UNITED STATES PATENT AND TRADEMARK OFFICE

Office Action Summary	Application No. 10/595,208	Applicant(s) AXELSSON, FOLKE	
	Examiner JOSE M. DIAZ	Art Unit 2879

DETAILED ACTION

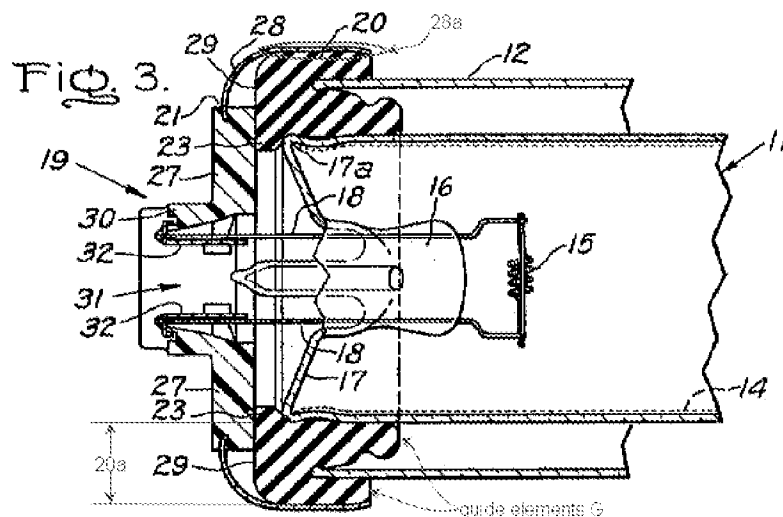
Regarding **claim 1**, Shanks clearly shows and discloses a fluorescent lamp, which comprises an elongated main tube (11), a fixing device (19) at each end of the fluorescent lamp (10) for fixing the fluorescent lamp (10) in a light fitting (it is inherent that there will be a fitting to accommodate the lamp), two electrodes (15) provided with emitter material placed inside the main tube (11), a heat-insulating outer tube (12) that surrounds the main tube (11) and creates an airspace between the main tube (11) and

the outer tube (12), each fixing device comprising an end cap (28) with a radial part, that delimits an outer end plane of the fluorescent lamp (10), and with an axial peripheral part (28a, denoted hereinafter by the Examiner in the figure below), characterized in that the axial peripheral part (28a) of the end cap (28) is connected to an end of the outer tube (12) and further comprising a one-piece axial spacer (20) made entirely of a material with low heat conductivity has a first end part (internal shoulder 23) which holds and centers an end of the main tube (11) and a second end part (20a, denoted hereinafter by the Examiner in the figure below) that adjoins the outer end plane and keeps the main tube (11) separate from the end cap (28), wherein the second end part (20a) of the spacer (20) has one or several radially-projecting guide elements (G, denoted hereinafter by the Examiner in the figure below)), against which the end of the outer tube (12) abuts (figs. 3-4, col. 2, lines 38-44 and 60-63, col. 3, lines 19-20, 27-30, 45-46).

Regarding **claim 4**, Shanks clearly shows and discloses that the guide element (G) is in the shape of a plurality of radial lugs distributed around the circumference (fig. 3 above).
